Access Compliance Report

Public Rights-of-Way

(Pedestrian Signals)

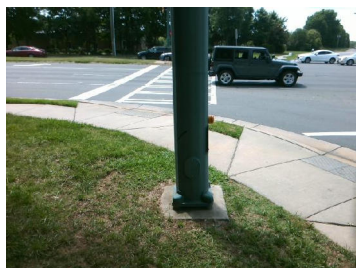
PROW/ADA: R410.6, R209.1, TMUTCD 4e.08, R404.1, R406.2, R404.7.3

N/A	B 1 FWD Approach Obstruction?	Yes	N/A	B 2 FWD Approach Obstruction?	Yes
N/A	B 1 FWD Approach Obstruction Dist (in)	5.0	N/A	B 2 FWD Approach ObstructionDist (in)	5.0
N/A	B 1 PARA Approach?	No	N/A	B 2 PARA Approach?	Yes
N/A	B 1 PARA Approach Constrained?	N/A	N/A	B 2 PARA Approach Constrained?	No
N/A	B 1 PARA Approach Reach (in)	N/A	No	B 2 PARA Approach Reach (in)	38.0
N/A	B 1 PARA Approach Width (in)	N/A	N/A	B 2 PARA Approach Width (in)	N/A
N/A	B 1 PARA Approach Obstruction?	N/A	N/A	B 2 PARA Approach Obstruction?	Yes
N/A	B 1 PARA Approach Obstruction Dist (in)	N/A	N/A	B 2 PARA Approach ObstructionDist (in)	5.0
N/A	B 1 Clear Floor Space Slope (%)	N/A	N/A	B 2 Clear Floor Space Slope (%)	N/A
N/A	B 1 Clear Floor Space XSlope (%)	N/A	N/A	B 2 Clear Floor Space XSlope (%)	N/A
N/A	B 1 PAR Slope (%)	2.5	N/A	B 2 PAR Slope (%)	4.4
Yes	B 1 Height (in)	40.0	Yes	B 2 Height (in)	38.5
Yes	B 1 Pressure (#)	2.0	Yes	B 2 Pressure (#)	2.0

Yes	B 1 Clear Xing Direction?	ClearlyMarked	Yes	B 2 Clear Xing Direction?	ClearlyMarked
	B 1 Crossing Direction	To SW		B 2 Crossing Direction	To SE
Yes	B 1 DistanceTo XWalk (in)	0.0	Yes	B 2 DistanceTo XWalk (in)	0.0
No	B 1 DistanceTo Curb (in)	151.0	No	B 2 DistanceTo Curb (in)	139.0
Yes	B 1 Diameter (in)	2.0	Yes	B 2 Diameter (in)	2.0

Possible Solutions: Replace Signal Push Button With APS Button on New Post. Remove & Replace Sign.
